Value Engineering For Transportation Improvements

SR 429 (Wekiva Parkway)/SR 417 and I-4 Interchange

Value Engineering Study Final Report

Project Description: Wekiva Parkway/SR 417 and I-4 Interchange

RECOMMENDATION No. 2: Adopt the I-4 Ultimate typical section

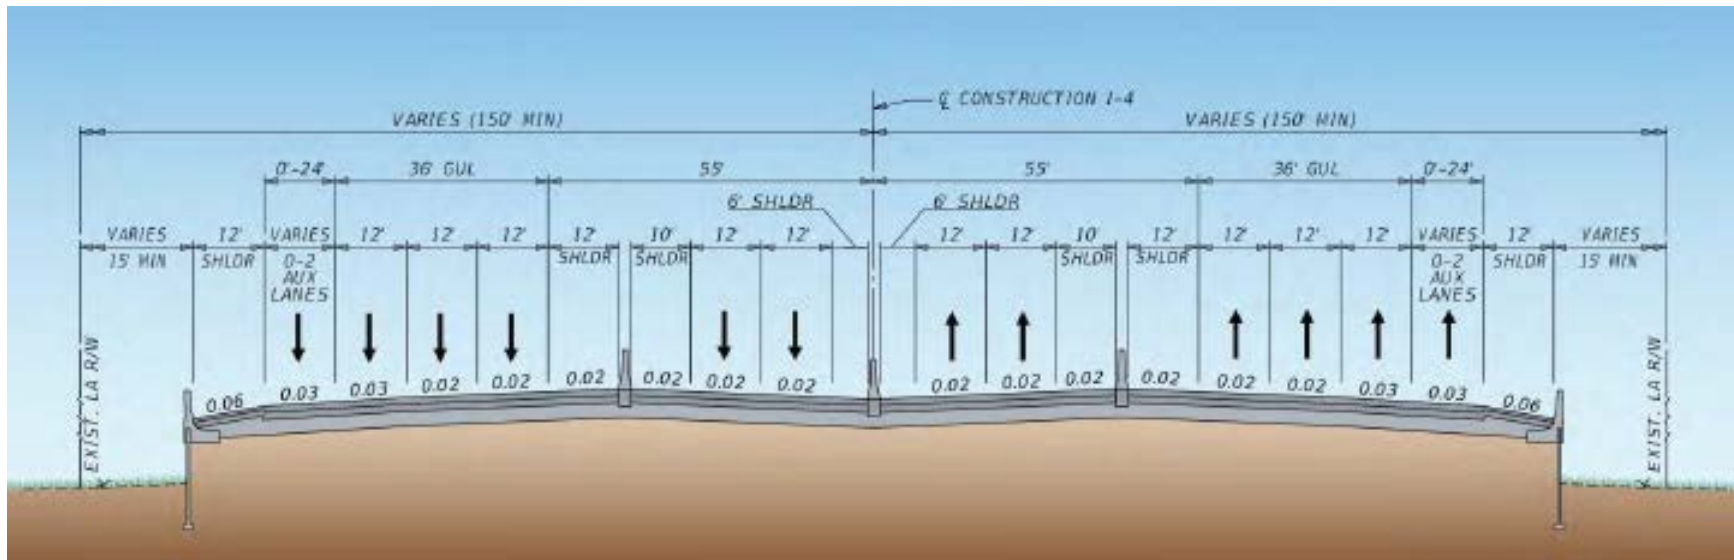
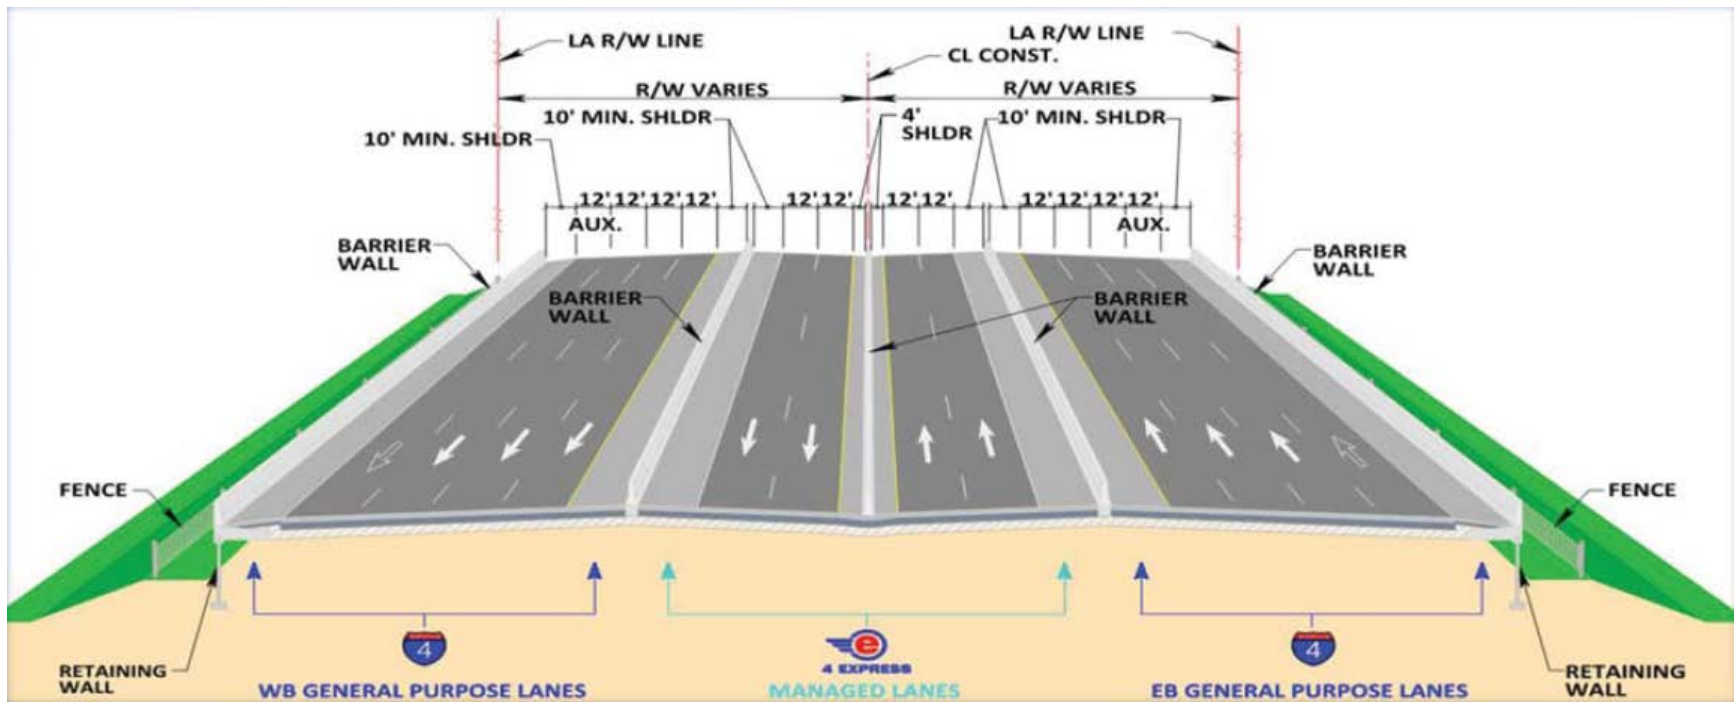
The PD&E Documents show a typical cross section of six general use lanes and four express lanes with 12-ft. inside and outside shoulders on the general use lanes and 10-ft. outside and 6-ft. inside shoulders.

- Smaller shoulders provide less space for disabled vehicles and emergency vehicles
- Requires a Design Variation

RECOMMENDATION No. 6 Modify the entrance to the westbound C-D to Station 2515+00:

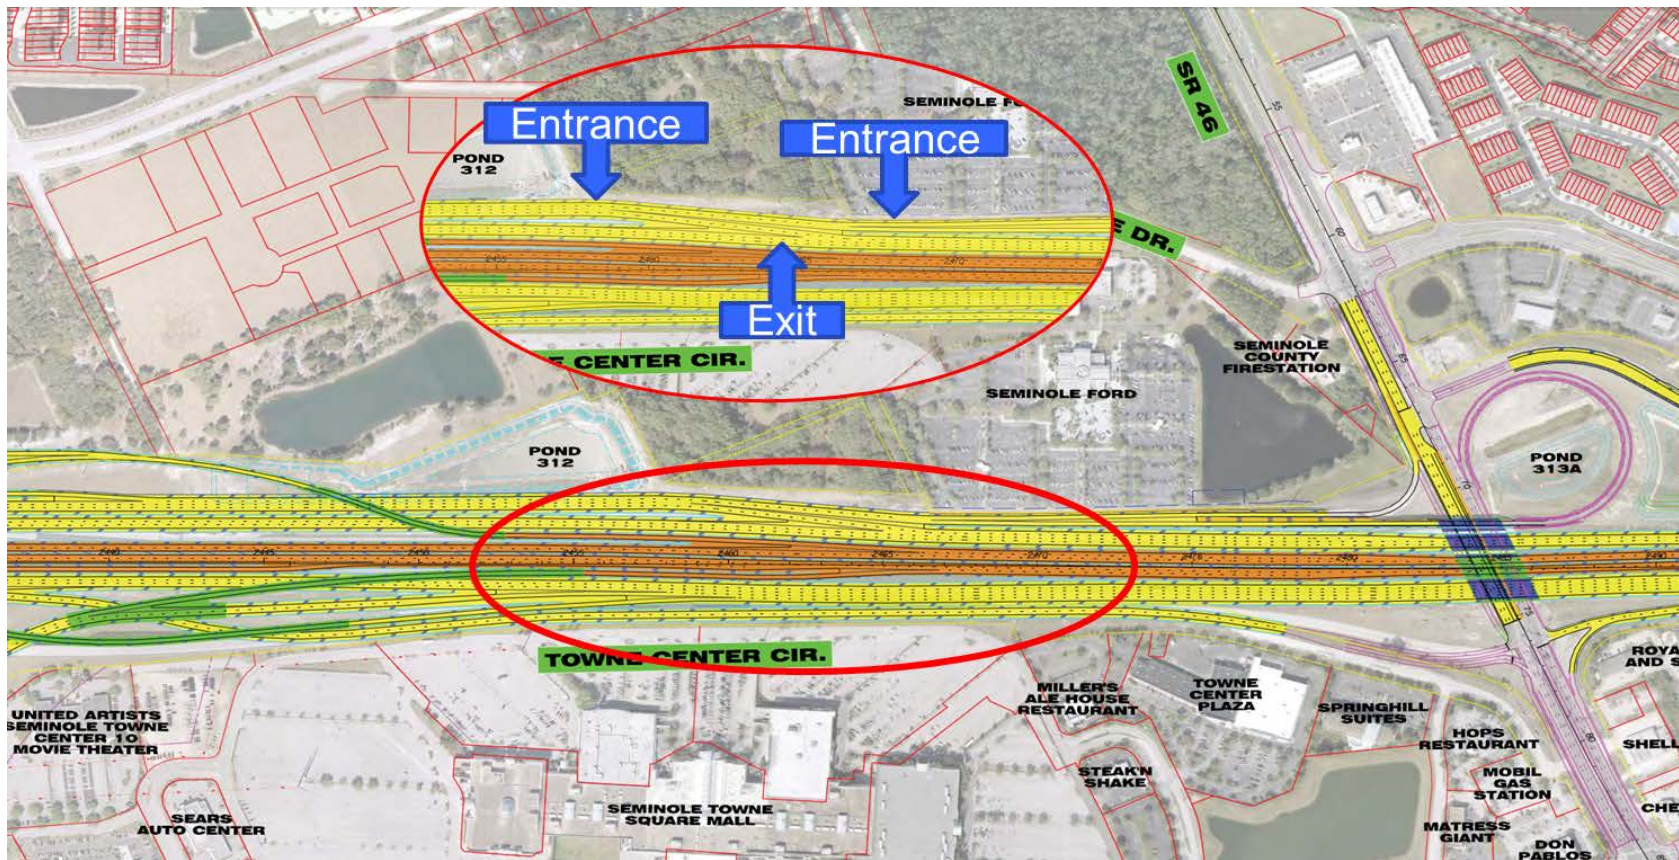
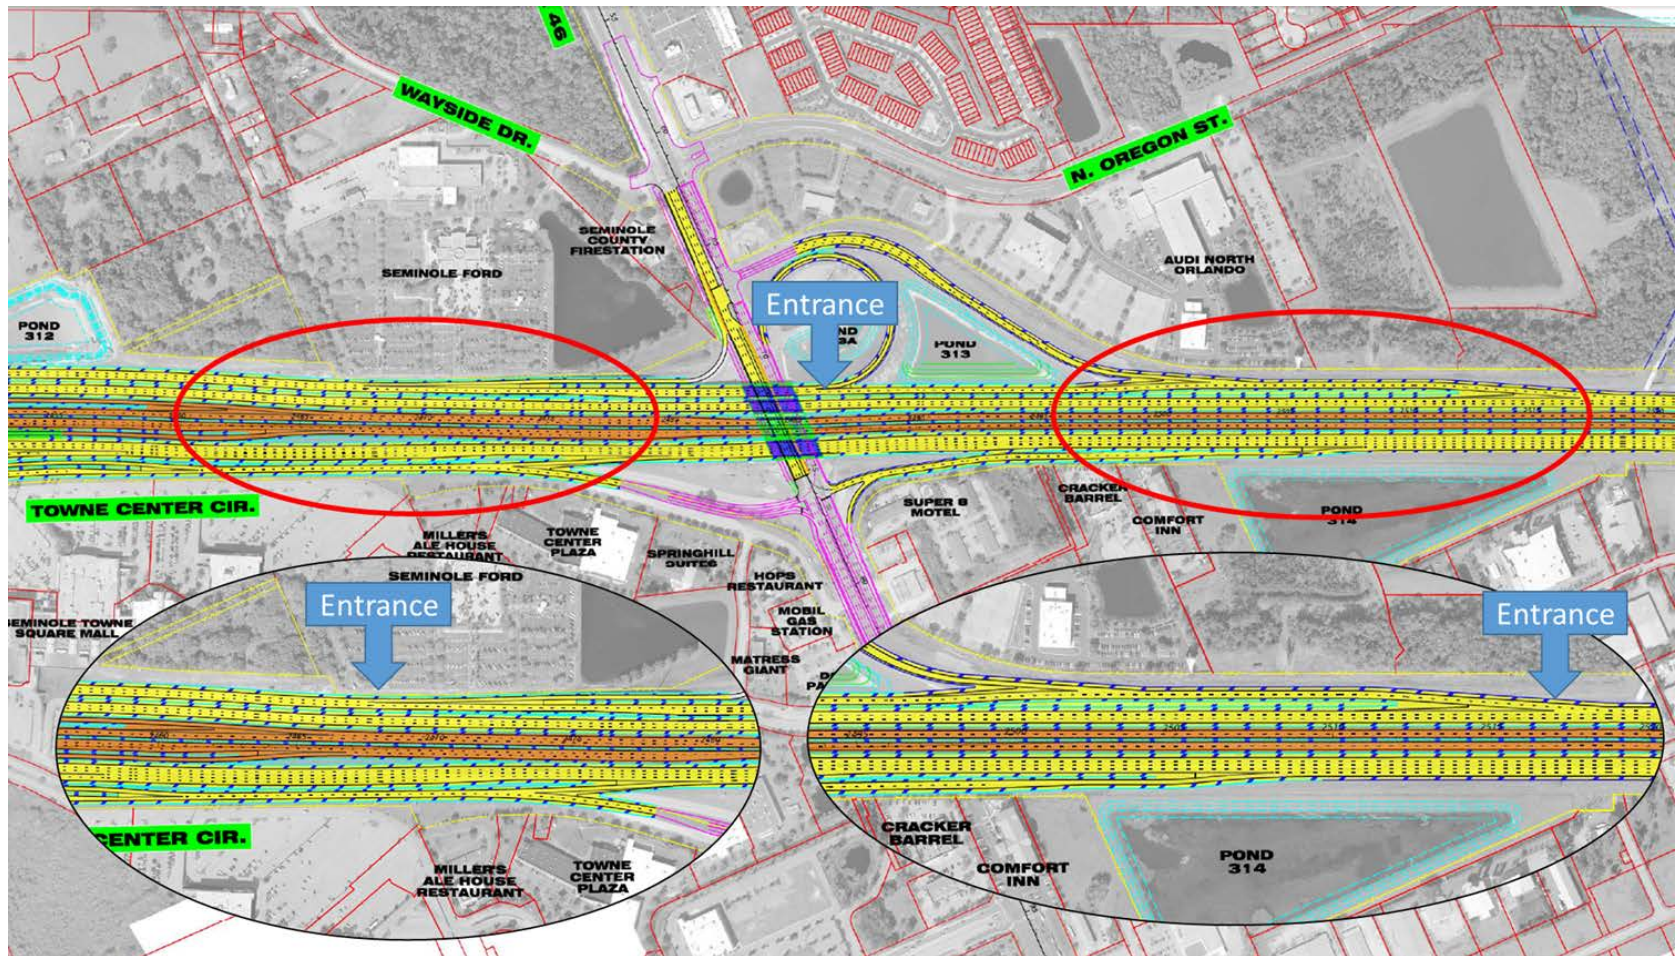
The PD&E Documents show the ramp entrance from the westbound general use lanes to the C-D road beginning approximately at station 2465+00. The C-D system continues under CR 46A and ties back into the westbound general use lanes.

RECOMMENDATION No. 9: Eliminate the right of way take on International Parkway in front the apartment complex (via variation)

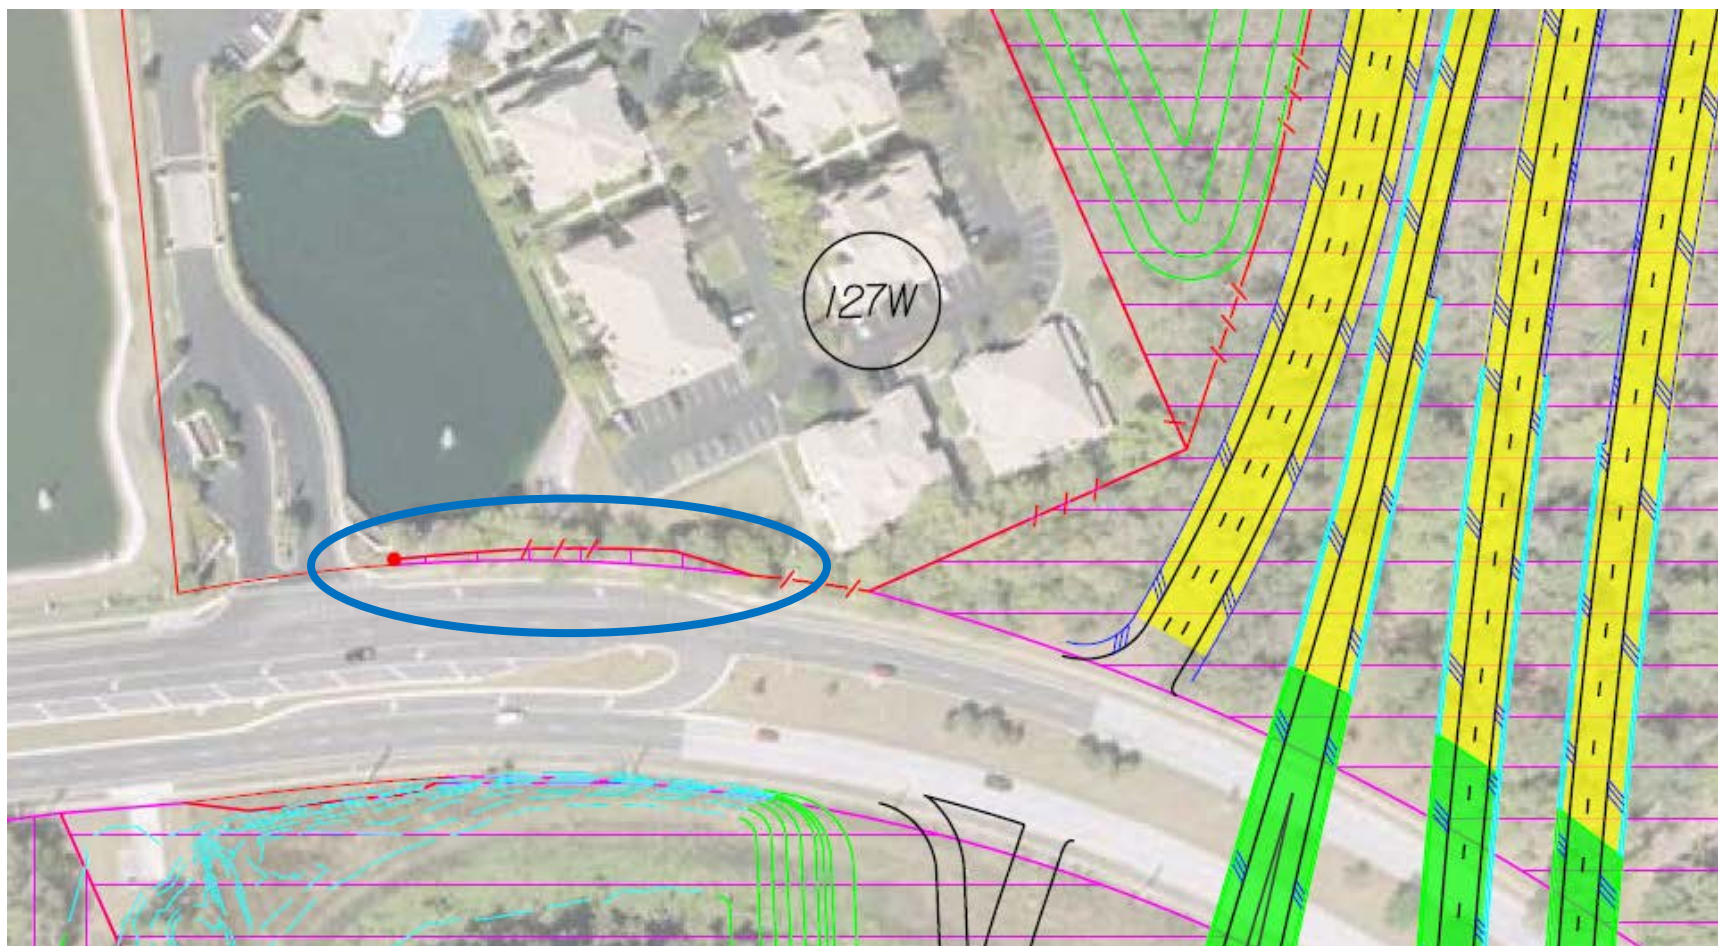
The PD&E Documents show a fee taking and a proposed limited access line in front of a parent tract improved with an apartment complex (Project Parcel # 127W).

The VE team recommends the elimination of this fee taking, as well as, limited access taking. These takings are proposed to meet design standards regarding controlled access from a ramp. The team believes a variation to the standard may be possible, if needed. This conclusion was reached based upon a field inspection where it was discovered that an 8-ft metal fence and large water retention facility exist in the area of these takings. It is the team's opinion that these existing improvements can function to provide the necessary access controls intended by the standard.

RECOMMENDATION No. 16: Eliminate the direct connects from SR 429 to I-4 for Express Lanes

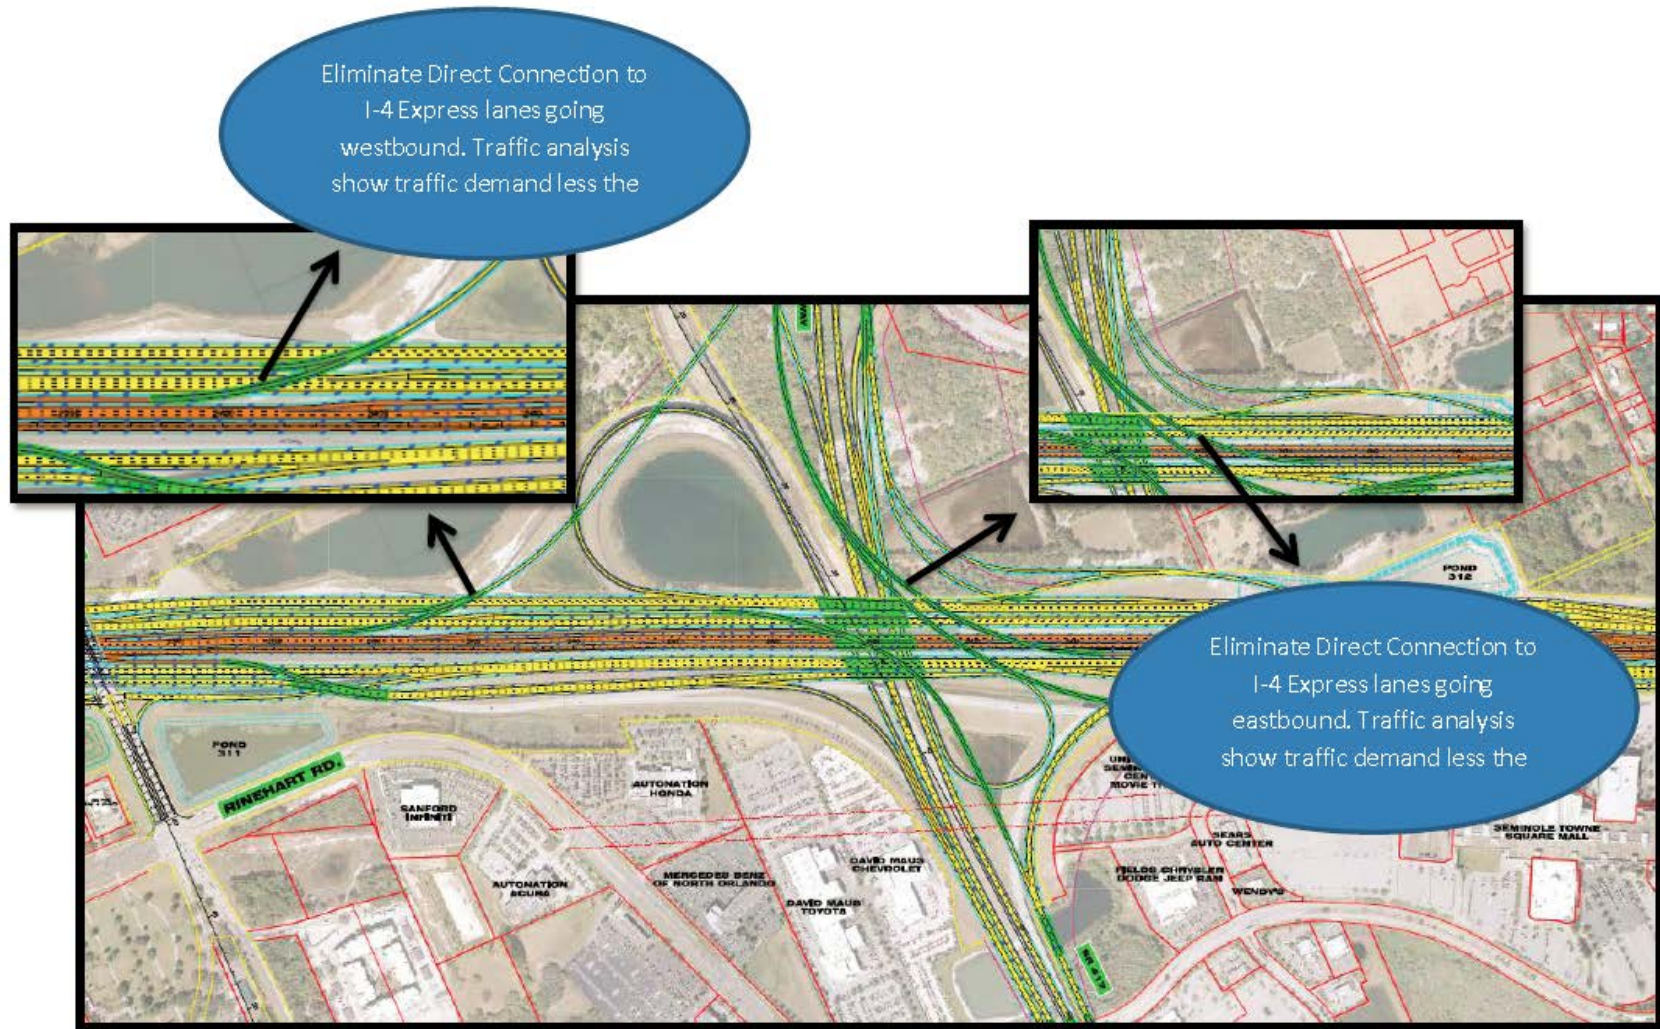
The PD&E Document show direct connections to I-4 express lanes going from SR 429 eastbound to I-4 eastbound and westbound.

Eliminate direct connections to I-4 express lane, going from SR 429 eastbound to I-4 westbound and from SR 429 eastbound to I-4 eastbound. An additional slip ramp could be constructed further north on I-4 to provide access to the express lanes going eastbound. There is already an existing slip ramp to I-4 express lanes going westbound just south of Lake Mary Boulevard proposed.

Recommendation 16: Eliminate direct connections to I-4 express lane, going from SR 429 eastbound to I-4 westbound and from SR 429 eastbound to I-4 eastbound. An additional slip ramp could be constructed further north on I-4 to provide access to the express lanes going eastbound. There is already an existing slip ramp to I-4 express lanes going westbound just south of Lake Mary Boulevard proposed. It's important to point out that traffic volume for the design year is expected to be below 200 vph at peak hour on these connections.

RECOMMENDATION No. 18: Salvage the existing connection from International Parkway to SR 417 to provide access to SR 417 southbound

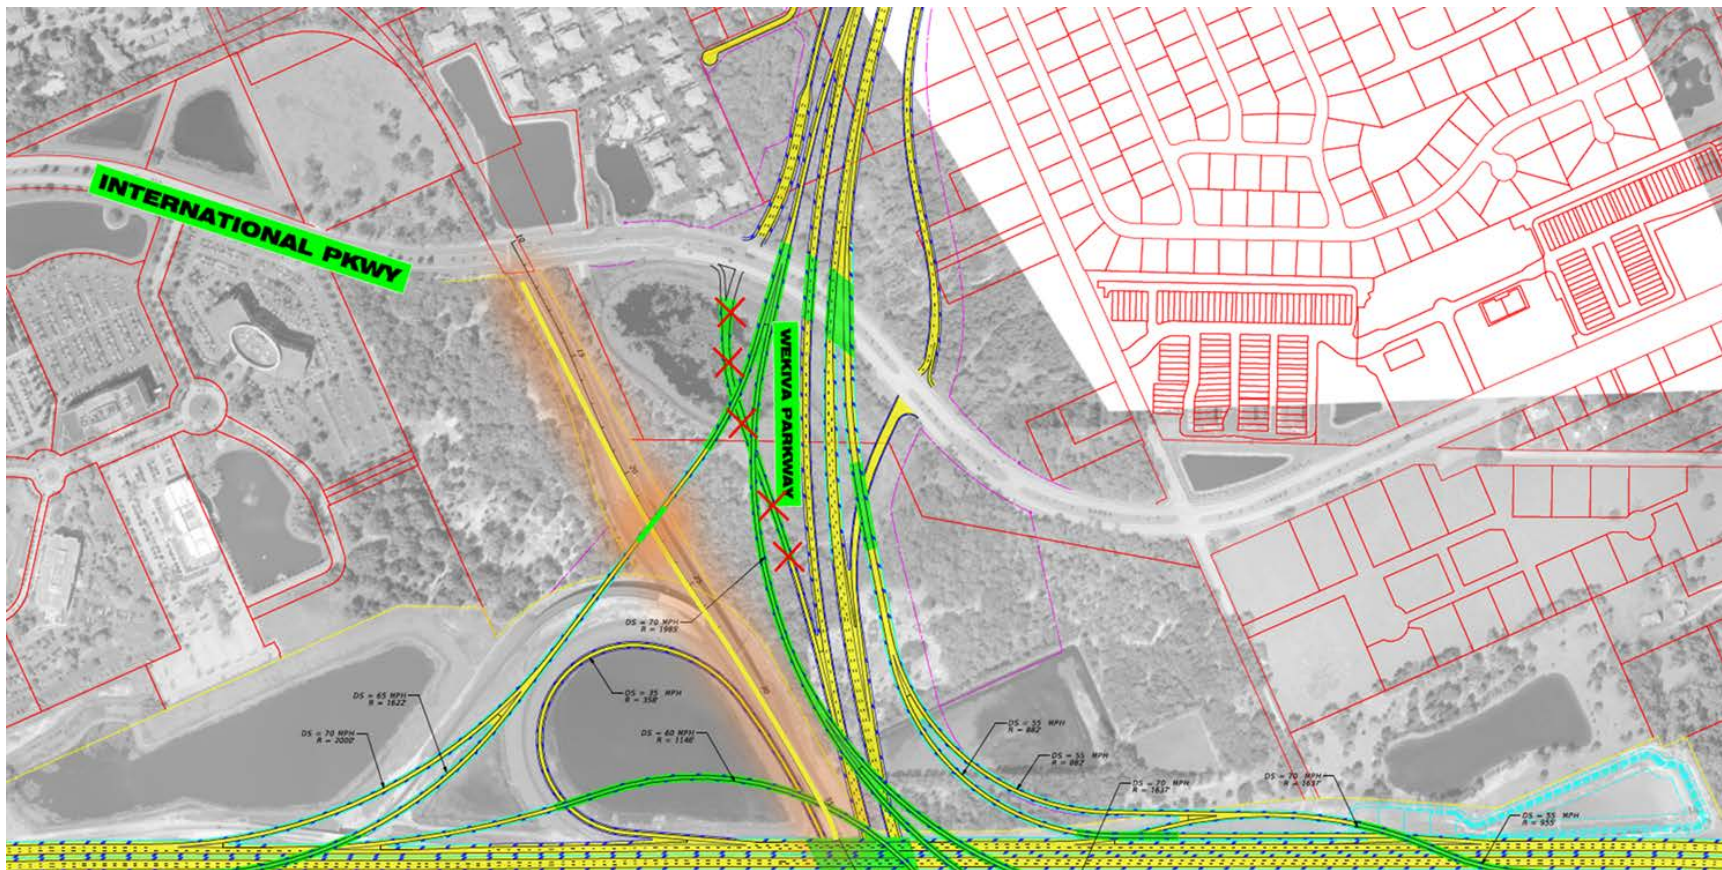
The PD&E Documents show constructing a new ramp on International Parkway for traffic to take SR 417 southbound. This ramp aligns with the SR 429 southbound off ramp.
